Access Compliance Report

Public Rights-of-Way

| Intersection ID: 10026800 | Main Street: FOREST_POINT_BV | Cross Street: N/A | Location: NW |
| ADA ID: 3FC1B5E513E5 | Ramp Type: PerpDiag | Initial Pass/Fail: Fail | Overall Compliance: No |

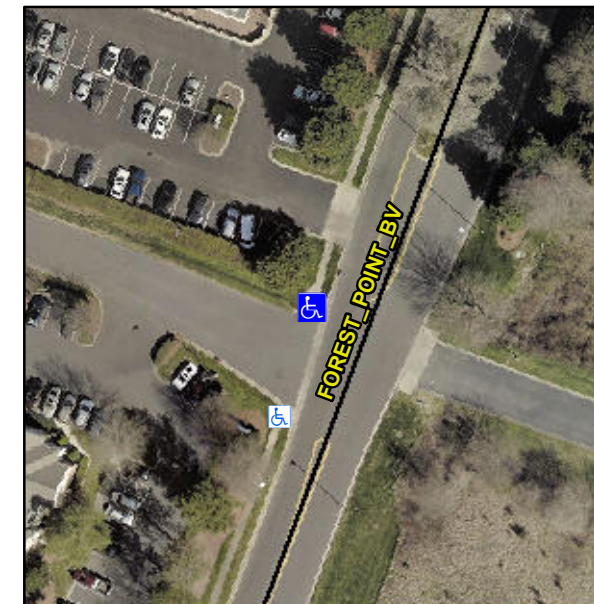
Not Found, R304.5.1, R304.2.2

| Compliance | Description | Data | Compliance | Description | Data |
|------------|-----------------------|-------|------------|-----------------------------|-------|
| N/A | Ramp Length (in) | 52.0 | No | Ramp Slope (%) | 8.8 |
| No | Ramp Width (in) | 35.0 | Yes | Ramp XSlope (%) | 4.9 |

Remove & Replace Curb Ramp With Two New Directional Ramps or Equivalent.
